1. 7:00 P.M. Planning Commission October 2020 Regular Meeting

Agenda
Planning Commission - Virtual Meeting
Wednesday, October 21, 2020 – 7:00 P.M.

- Medical & Recreational Marihuana Zoning Text Amendments.
 - Public Hearing
- Site Plan Review: Avenue Market at 902 W Michigan.
- Special Use Permit & Site Plan Review: 201 N Park.
 - Public Hearing

SHEET TITLE:
SITE DRAINAGE PLAN

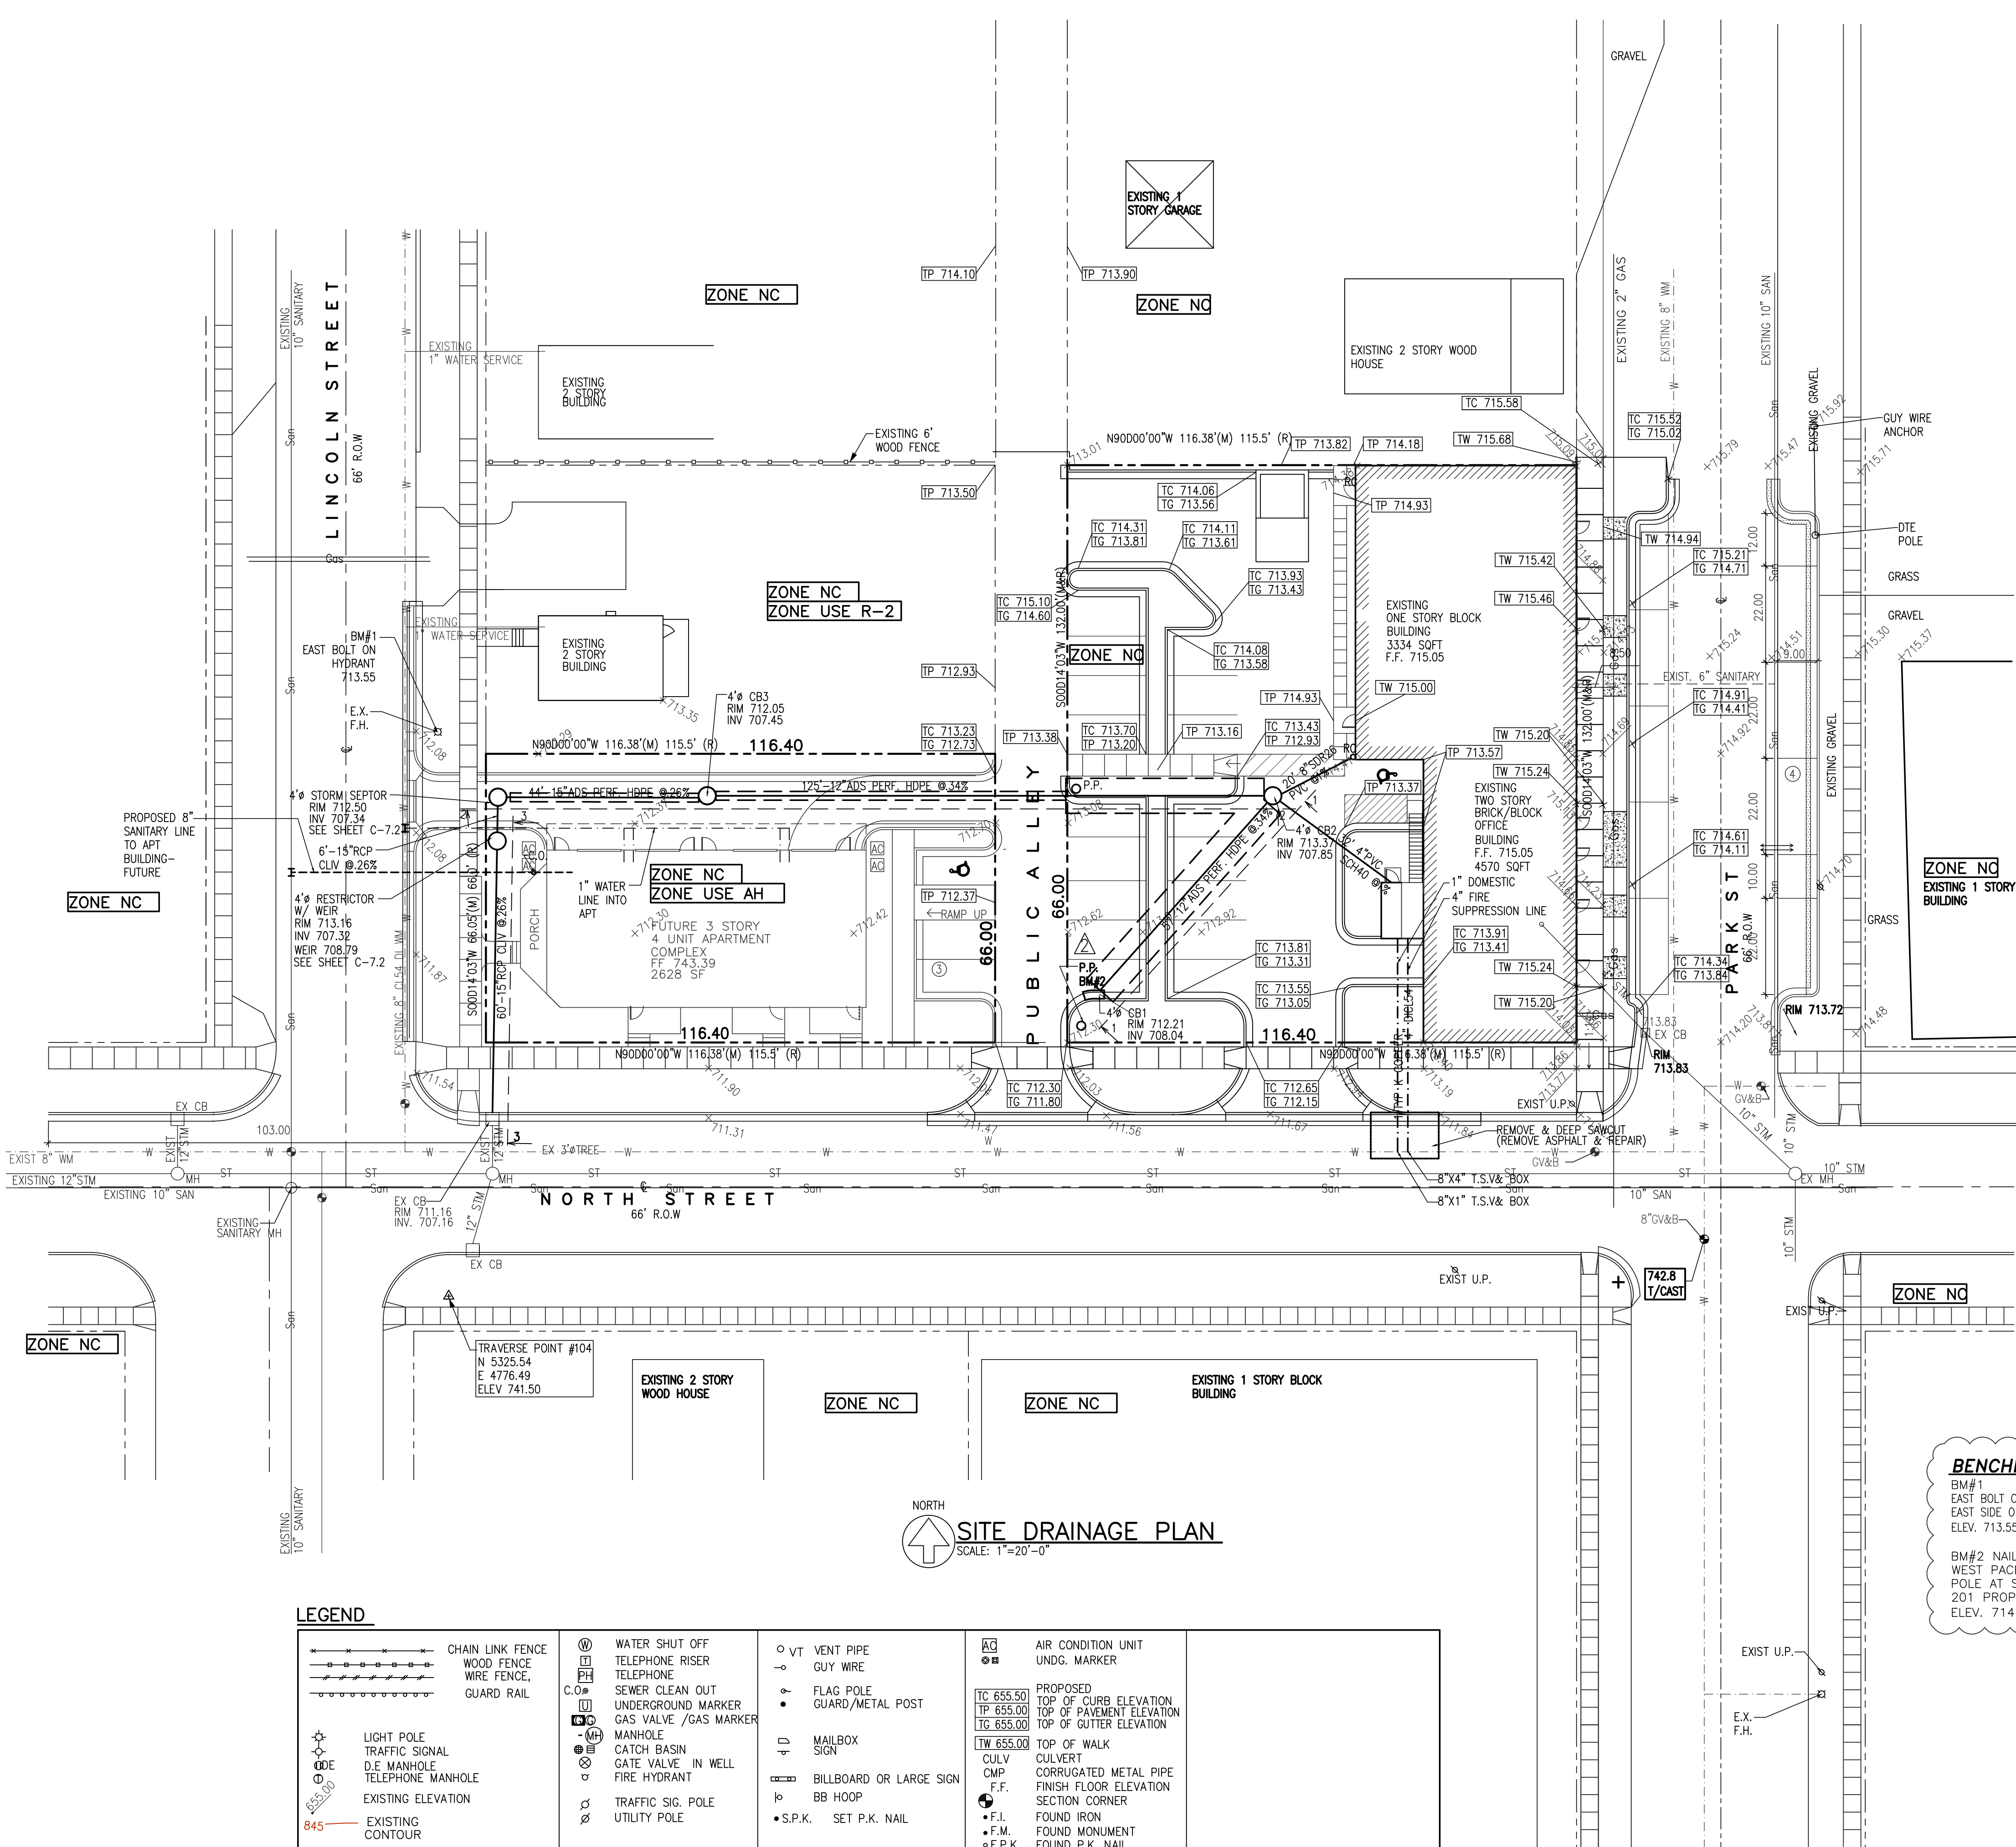
11. Brick paver pavement cross section detail should be provided on the plans as well as proposed flagpole foundation detail.
12. Remove note on sheet C-4 Site Drainage Plan that says “Existing 6-inch” with a leader pointing to the existing water main along North Street. The water main is 8-inches diameter. Any improvements to the water or sanitary sewer systems will require review and approval from YCUA.

- a. (Answer): There is no brick paver pavement on plans and flag poles have been eliminated on project.
- 12. Remove note on sheet C-4 Site Drainage Plan that says " Existing 6-inch" with a leader pointing to the existing water main along North Street. The water main is 8-inches diameter. Any improvements to the water or sanitary sewer systems will require review and approval from YCUA.

STORM SEWER PROFILE 1-1

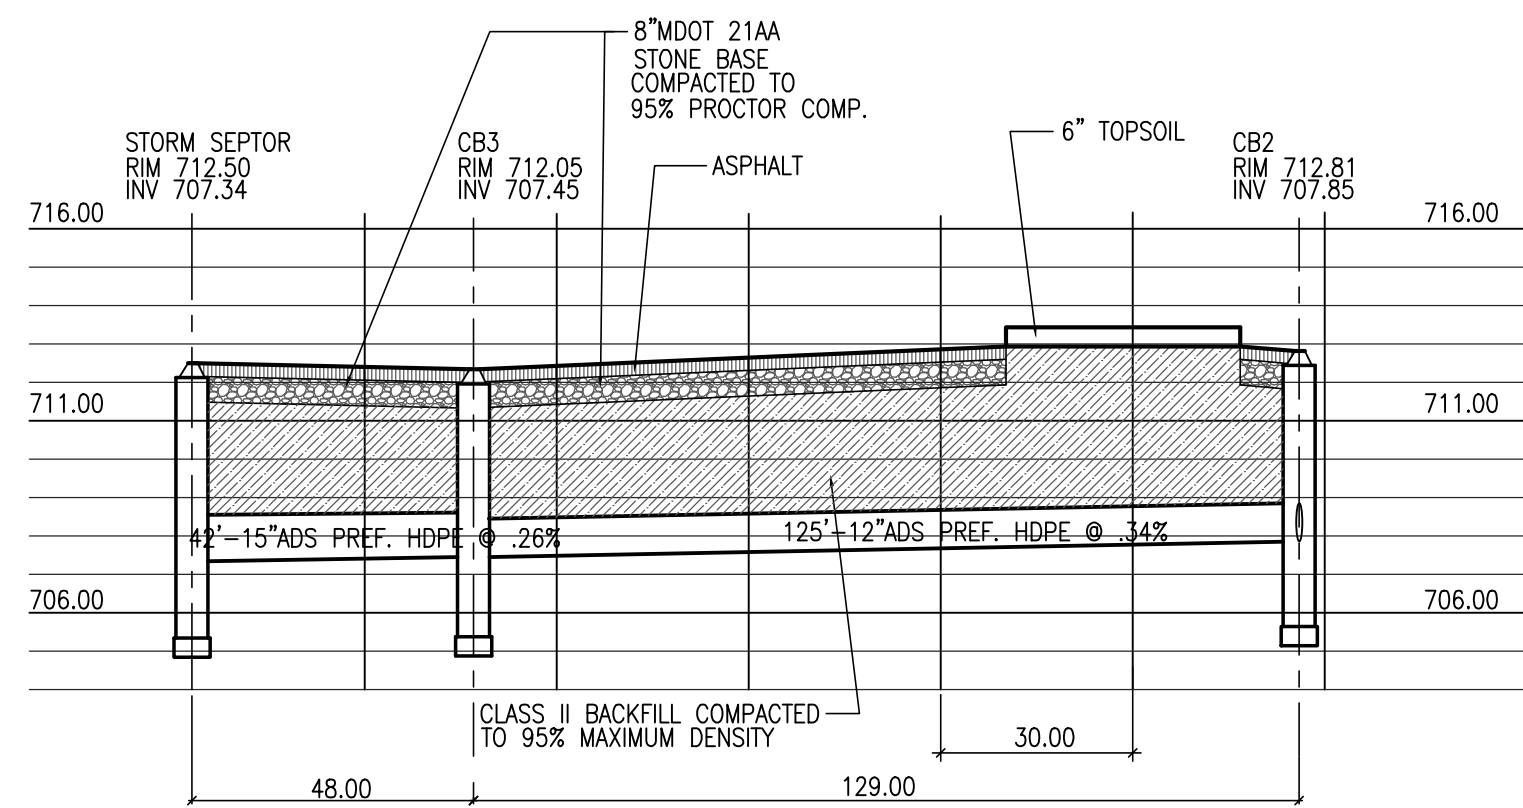
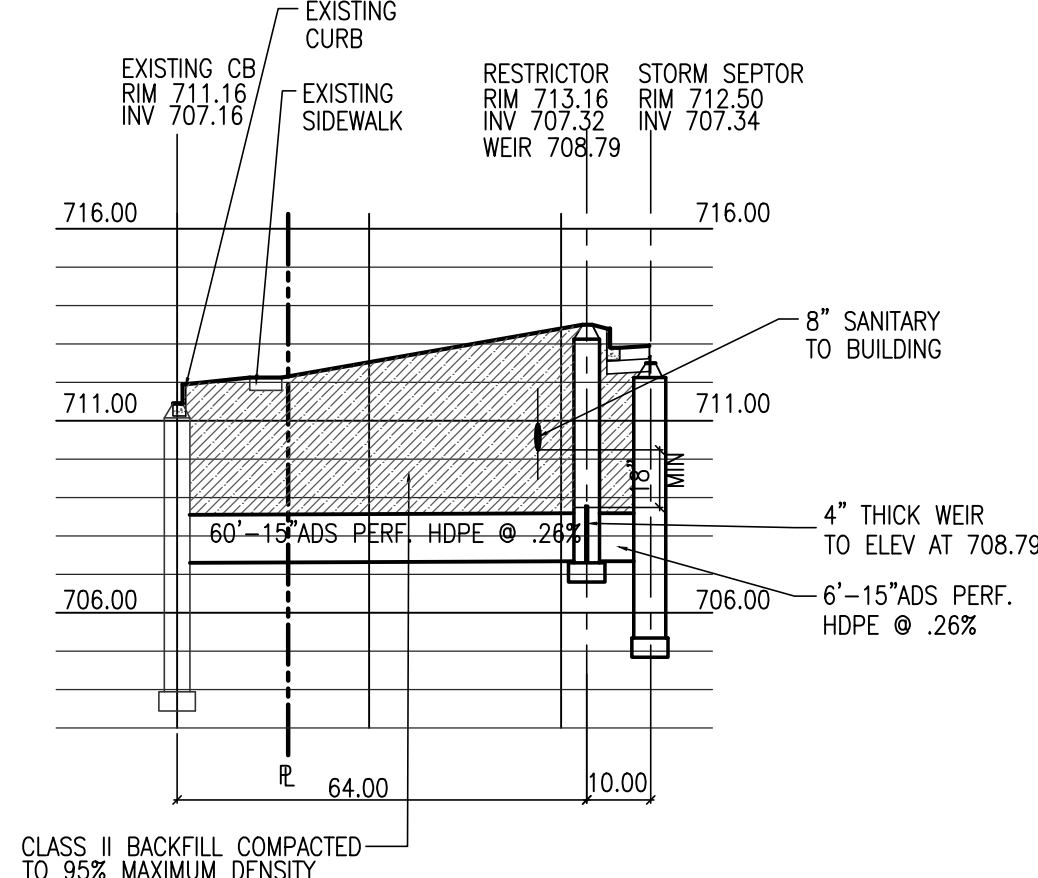
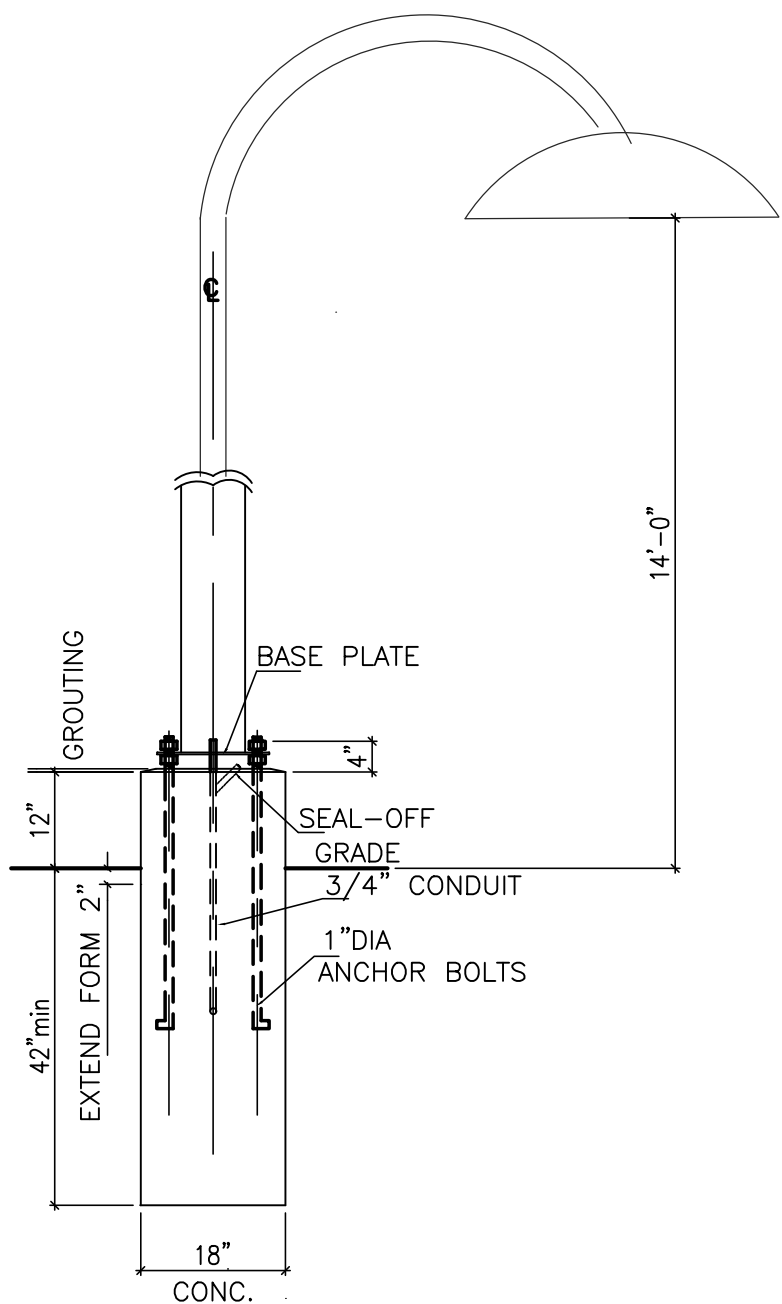
13. Existing sanitary lead to 201 N Park Street shall be shown on the drawings.
14. Storm sewer profiles show 8-inch MDOT 22AA stone base under asphalt pavement, but the asphalt detail has 6-inch 21AA aggregate base. Please clarify which section is proposed.

14. Storm sewer profiles show 8-inch MDOT 22 AA stone base under asphalt pavement, but the asphalt detail has 8-inch 21AA aggregate base. Please clarify which section is proposed.
